BAR Meeting
June 19, 2013

ISSUE: Permit to Demolish/Capsulate and Addition/Alterations
APPLICANT: Andrew and Tamara Saltonstall by Patrick Camus
LOCATION: 217 South Fairfax Street
ZONE: RM / Residential

BAR2013-00169 & BAR2013-00170

1 PARTIAL FRONT ELEVATION - PROPOSED

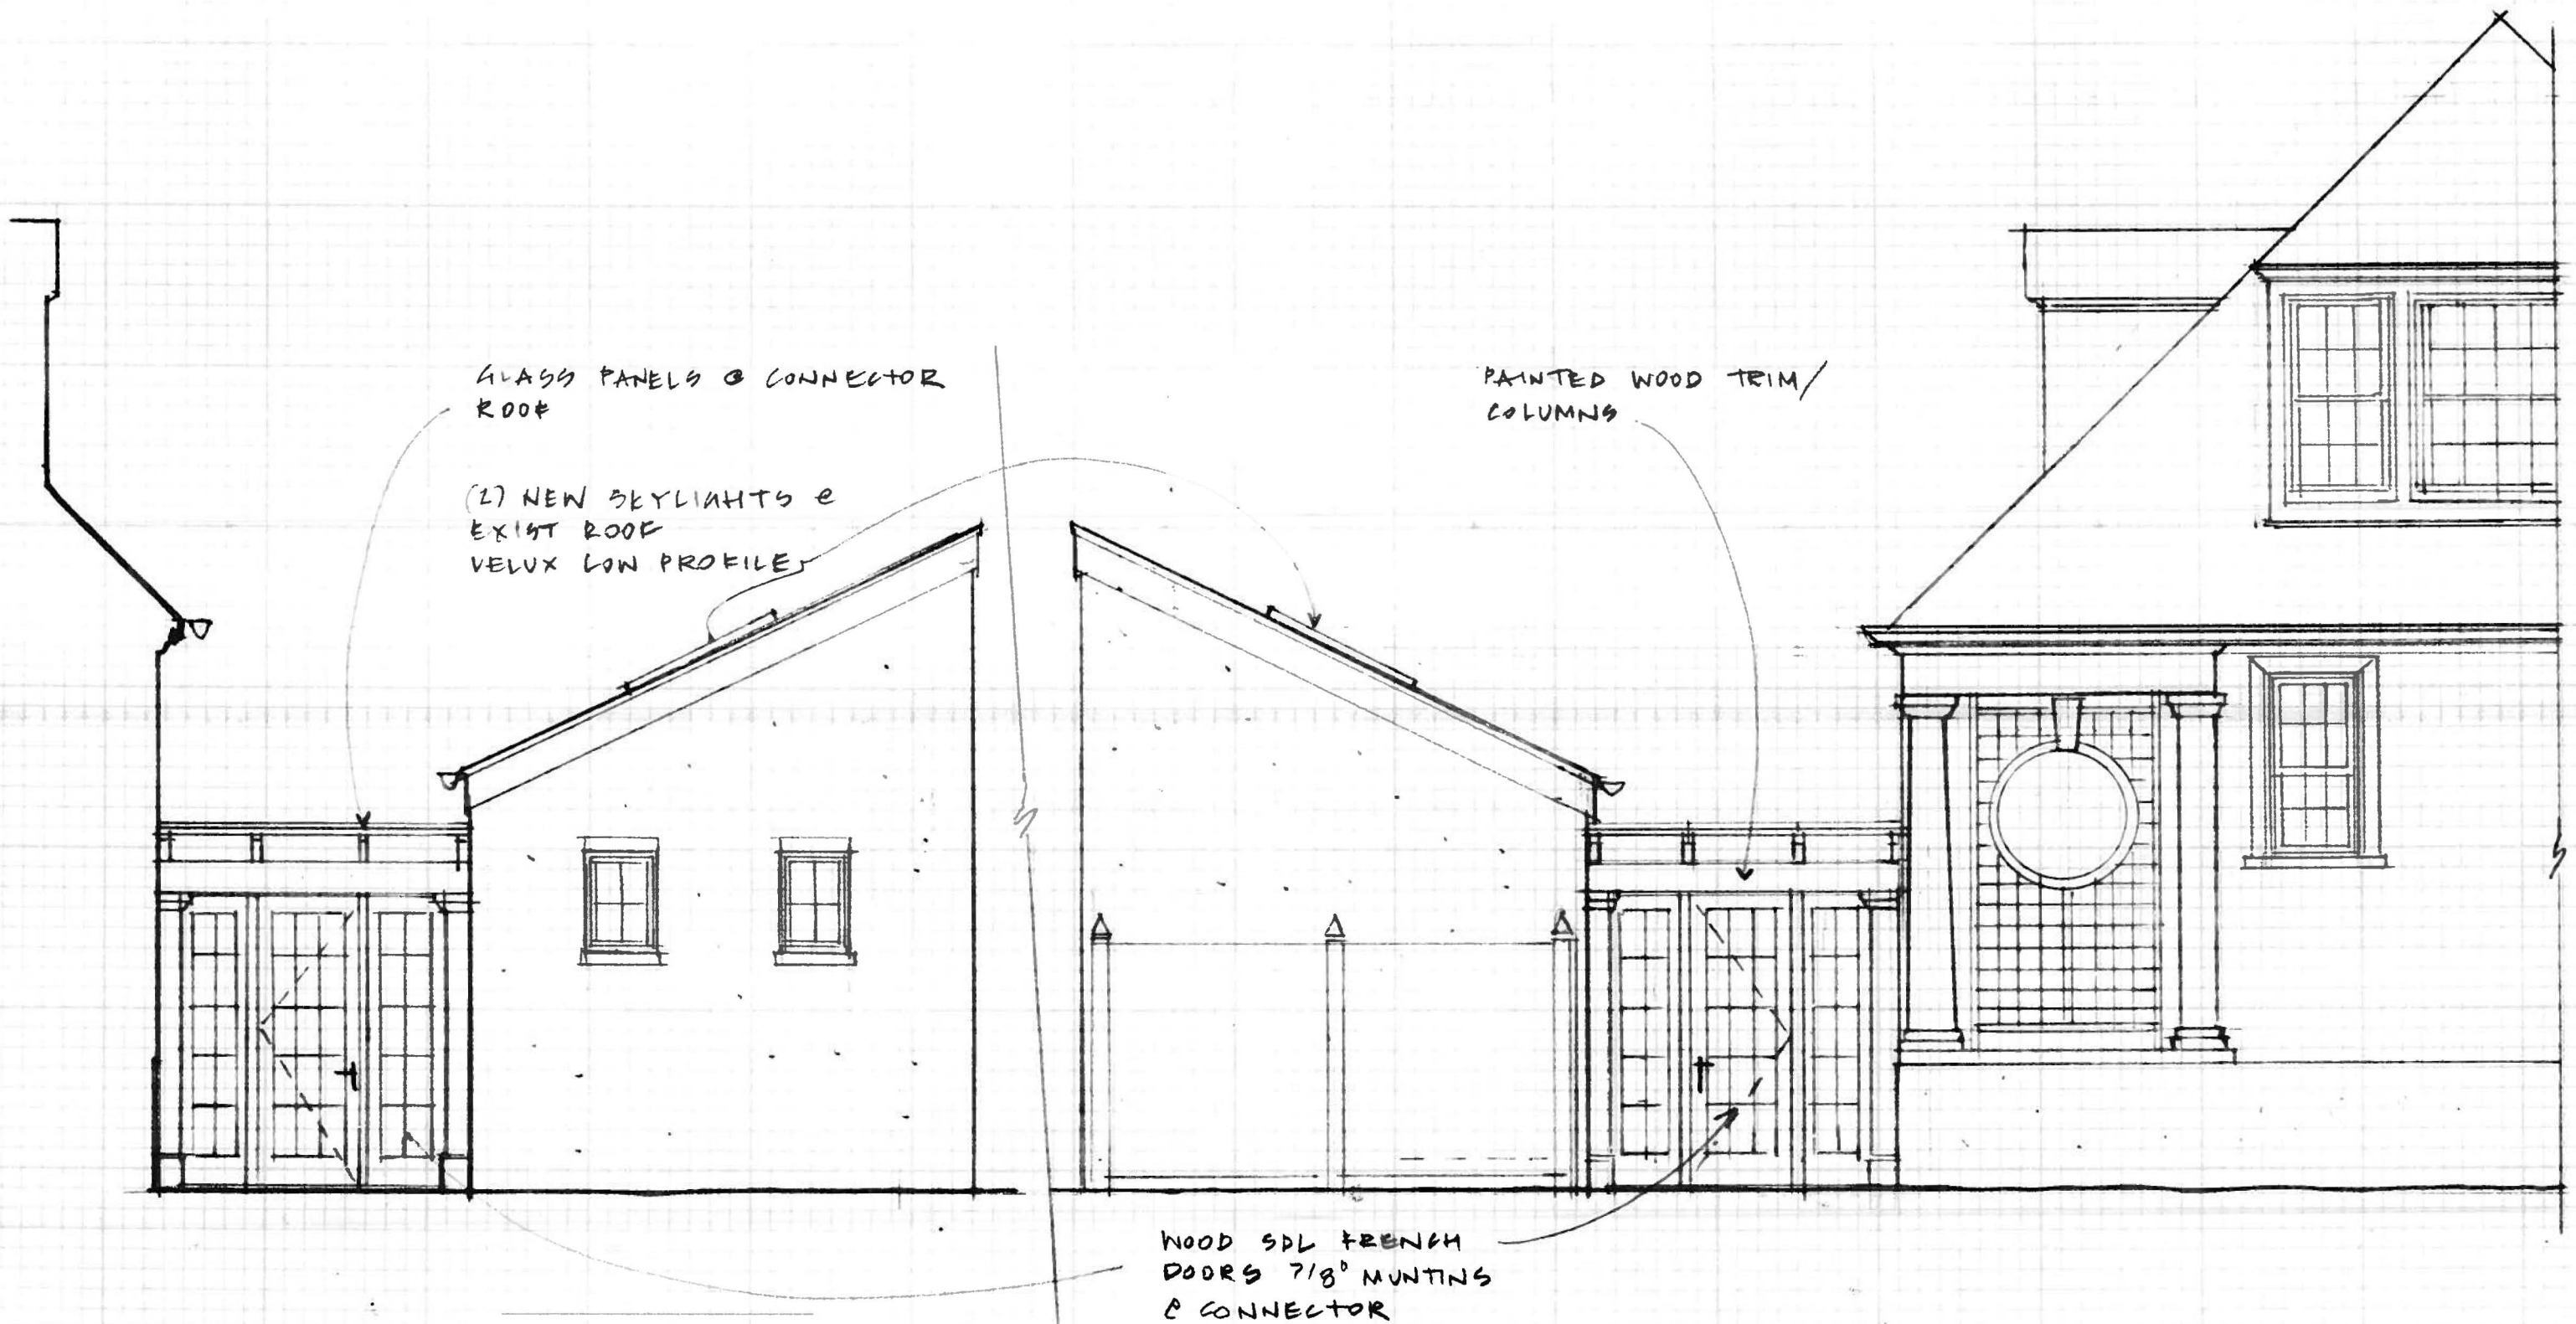
Staff is concerned about the at-grade one-story addition which will link the existing residence to the historic outbuilding. While the existing south wall will be capsulated and not demolished, the addition of this connector significantly compromises the historic integrity of the freestanding structure and further enlarges the footprint of this significant house. Outbuildings play a significant role in the history of Old Town, as they add a visible layer to the history of neighborhood development. Staff recommends denial of this portion of the application. Staff could support a simple trellis connecting the two features.

Staff has no objection to the installation of two low-profile skylights on the south slope of the outbuilding roof. An inspection of the outbuilding reveals that what was once likely a utilitarian building has had a number of repairs over the years, the building has relatively new roof rafters and the building has been dry walled. The roof is relatively new. The loss of historic fabric on the roof is minimal and visibility of the skylights will be extremely minimal.
